# Cross Guns Bridge

Quality Audit

Bindford Ltd

January 2021

**Figure 1 – Proposed Access Treatment**

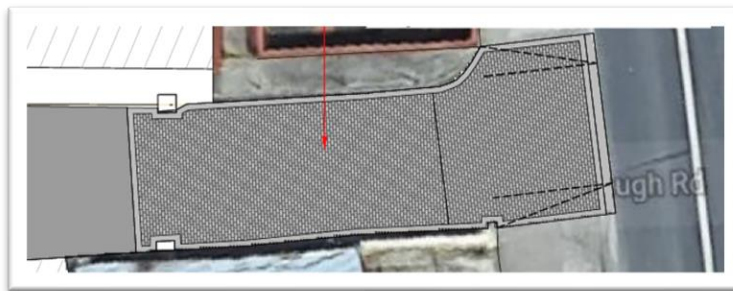
**Location:** Footpath Fronting Access to Phibsborough Road

Several in-combination factors serve to place pedestrians at risk of vehicle strike at this location:

1. The height of the Third-Party garden boundary wall on the right-hand side of the access point for emerging vehicles, serves to limit visibility to pedestrians on the footpath.
2. The block paving material proposed for the access road extends beyond the adjacent boundary walls and through the public footpath onto Phibsborough Road. It extends to the edge of the adjacent traffic lane, suggesting priority for emerging vehicles over pedestrians walking on the footpath.
3. A stop line is proposed (on the engineering drawings) which encourages emerging drivers to 'roll through' the public footpath before stopping at the edge of the adjacent northbound traffic lane on Phibsborough Road.

The Designer should investigate if the Third-Party boundary wall can be lowered or adjusted by agreement. The concrete public footpath which passes the access should be retained (uninterrupted) to demonstrate that pedestrians have priority over vehicles and the stop line should be relocated to a position which requires drivers to stop in advance of crossing the footpath.

3.1	Yes	Yes	<p>The intention will be that cars exiting the premises will exit in a two-part stop fashion. The first stop will occur at the stop sign prior to the pedestrian crossing, with the second stop at road edge. The driver will be able to assess the pedestrian crossing and oncoming traffic in both cases in order to ensure it is safe to proceed.</p> <p>This two-part stop will ensure that the required sightlines are valid for the driver exiting the premises.</p> <p>The option of lowering the 3<sup>rd</sup> party wall will be investigated and may be lowered at a future date, if possible.</p> <p>The pedestrian footpath will not be affected by works proposed on the subject site as the paving lines will be retracted to behind the pedestrian crossing in order to ensure pedestrian priority.</p> <p>Lastly, there is a shared footpath located adjacent the entrance road of the subject site that can be used by pedestrian who might be uncomfortable with the surrounding vehicles.</p>	Noted.

**Figure 3 – Conflict at Top of Ramp**

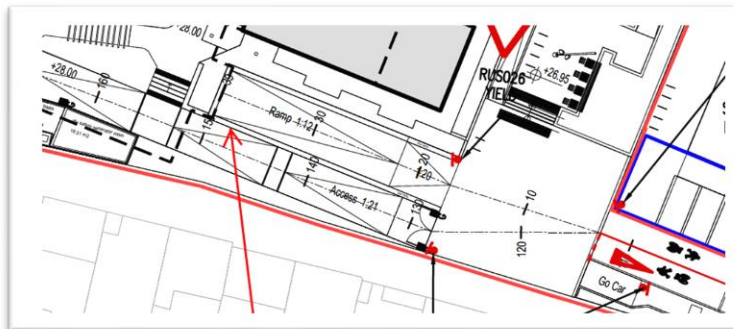
**Location:** Top of Ramp to Underground Car Park

Vehicles emerging from the internal public realm area and the underground car park ramp simultaneously could come into conflict as they attempt to merge and exit.

The Designer should ensure that the boundary treatment which will separate the emerging traffic streams permits intervisibility between dualling vehicles. The exit points should be staggered in a longitudinal sense and priority control measures should be prescribed to instruct (only) the lesser used arm using a stop or a yield provision.

3.4	Yes	Yes	<p>Please refer to Drawing 20-011-P195 Rev A which shows the required treatment for the ramp area.</p> <p>Along with the respective stop – and yield signs proposed for the ramp area, there is also a gateway proposed at the start of the ramp leading up to the public realm.</p> <p>The wall separating the two ramps will be a low structural wall with a height of c. 250mm. Railings are proposed on top of the structural wall which do not block visibility, ensuring adequate vision for both drivers using the ramps.</p> <p>Due to the low speed and low traffic frequency environment, it can be concluded that the above-mentioned measures will suffice and that additional priority control measures would not be required.</p>	Noted.

**Figure 4 - Sharp Horizontal Changes in Direction**

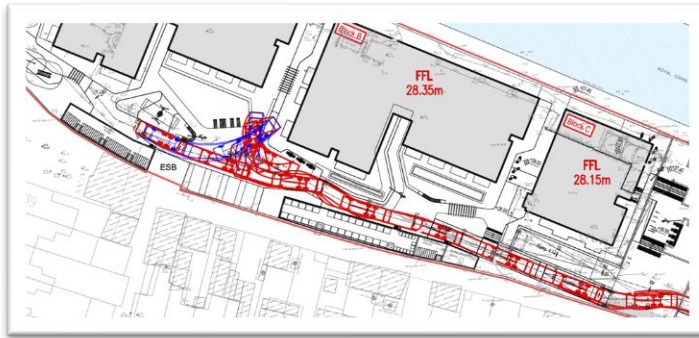
**Location:** Internal Public Realm / Recreation Area

The long-term requirement for vehicles to manoeuvre, reverse and turn within the confined space allocated for shared use could lead to vehicle strikes on landscaping features and conflicts with vulnerable road users.

If the Designer cannot remove this risk at source, then a suite of mitigation measures should be developed. Such mitigation measures might include robust access control to physically prohibit unauthorized vehicle admission, mandating that service vehicle sizes are limited, management of service vehicle arrival times and the compulsory use of a banksman to accompany all service vehicles and oversee reversing manoeuvres.

3.5	Yes	Yes	Refuse collection for the premises will occur at same time each week which would enable suitable planning for the refuse vehicle entering the subject site.	Noted.

Problem Reference (Section 2)	Designer Response Section			Audit Team Response Section
	Problem Accepted ( yes / no )	Recommended Measure Accepted ( yes / no )	Alternative Measures or Comments	Alternative Measures Accepted ( yes / no )
			<p>The refuse vehicle also has 2 additional staff members that can be instructed to act as banksman and direct the vehicle as required.</p> <p>The other abnormal vehicles that would enter the premises are emergency vehicles. Emergency vehicles would also have additional staff to act as banksman to ensure no vehicle strikes occurring on the premises.</p> <p>Additionally, emergency vehicles are fitted with flashing lights and sirens which would make their presence known to the pedestrians in close vicinity. In this regard, all risks pertaining to emergency vehicles would be adequately covered.</p>
